SUBJECT: DONALD C. COOK NUCLEAR PLANT, UNIT NOS. 1 AND 2 - ISSUANCE OF
AMENDMENTS RE: INCREASED STEAM GENERATOR PLUGGING LIMIT (TAC NOS.
M92587 AND M92588)

The Commission has issued the enclosed Amendment No. 214 to Facility Operating License No. DPR-58 and Amendment No. 199 to Facility Operating License No. DPR-74 for the Donald C. Cook Nuclear Plant, Unit Nos. 1 and 2. The amendments consist of changes to the Technical Specifications (TS) in response to your application dated May 26, 1995, and supplemented September 26, 1995, August 2, 1996, and February 6, 1997.

The amendments revise the TS to allow operation of Cook Unit 1 at steam generator tube plugging levels up to 30%. Additional changes to increase operating margins for both Unit 1 and Unit 2 are also included.

Amendment No. 214
License No. DPR-58

Figure 2.1-1 Reactor Core Safety Limits

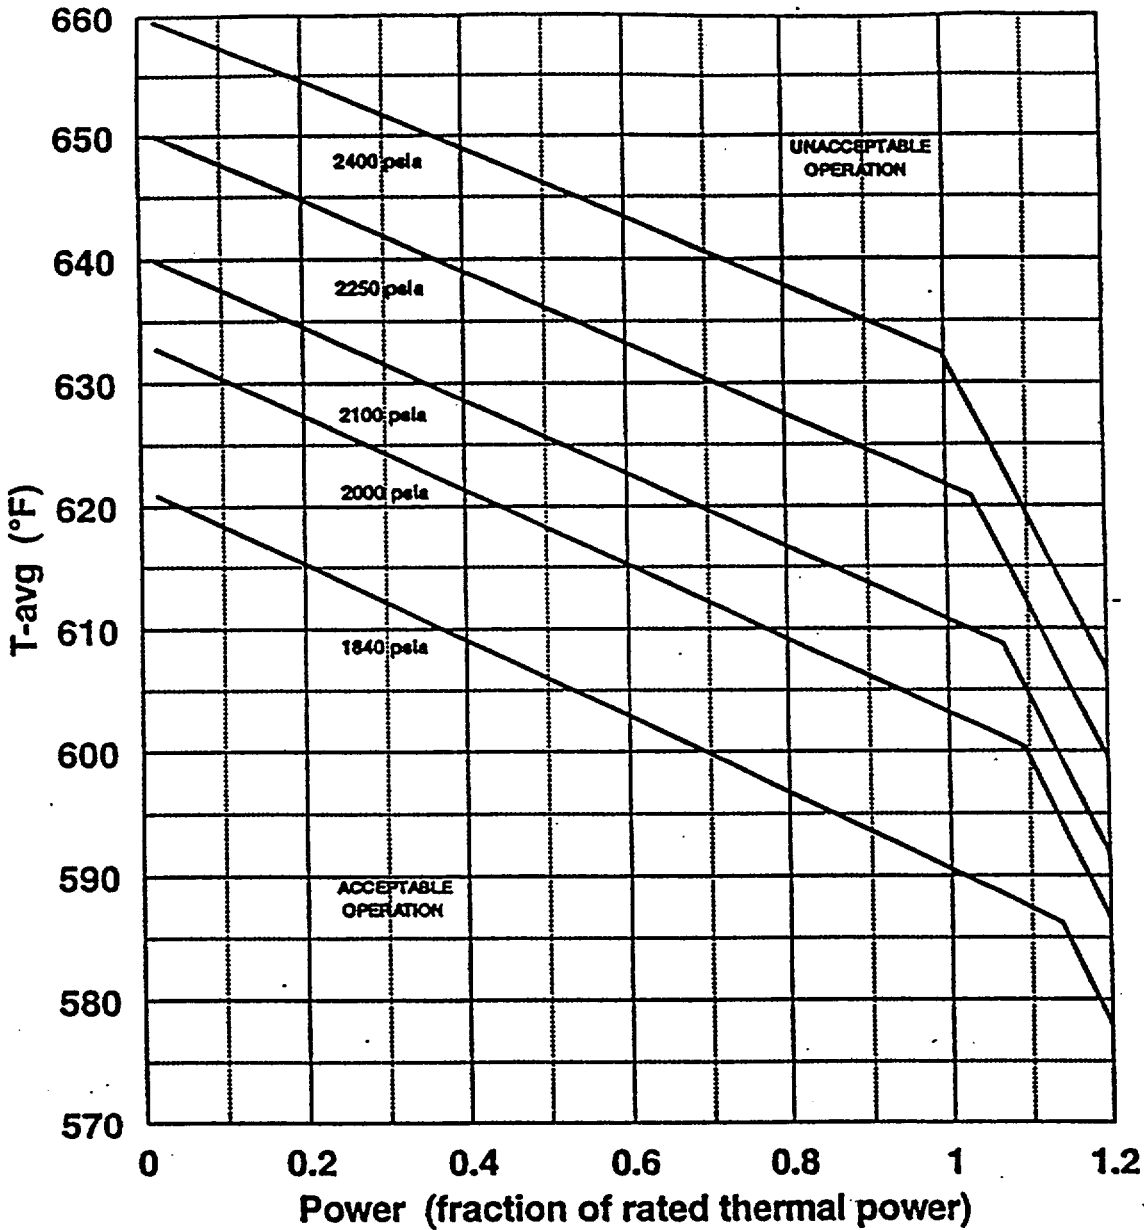
TS pg. 2-2; Figure 2.1-1: Reactor Core Safety Limits were revised. This change was proposed to increase Unit 1 operating margin. The revised OTDT and OPDT setpoints are based upon new core thermal safety limits, which account for the effects of the Reactor Coolant System (RCS) parameter changes associated with the increased level of SGTP, using the methodology described in Reference 5. These setpoints were revised to increase the available margin between the safety analysis setpoint values and the nominal, or TS values, such that more delta-T drift could be accommodated between instrumentation calibrations during the fuel cycle. Presently, the power margin associated with the Rerating Program is being utilized to offset the delta-T drift that is being experienced during core burnup (i.e., the core power of 3411 Mwt is supported by the analyses, but the plant is actually operated with a core full-power value of 3250 Mwt). However, since the 30% SGTP parameters do not have this power margin available, there was a need to revise the OTDT and OPDT setpoints as part of the SGTP Program.

PRESSURE (PSIA)	BREAKPOINTS (FRACTION RATED THERMAL POWER, T-AVG IN °F)		
1840	(0.02, 620.86),	(1.136, 586.17),	(1.2, 577.94)
2000	(0.02, 632.79),	(1.094, 600.31),	(1.2, 586.52)
2100	(0.02, 639.85),	(1.068, 608.72),	(1.2, 591.77)
2250	(0.02, 649.96),	(1.031, 620.83),	(1.2, 599.40)
2400	(0.02, 659.52),	(0.996, 632.42),	(1.2, 606.63)
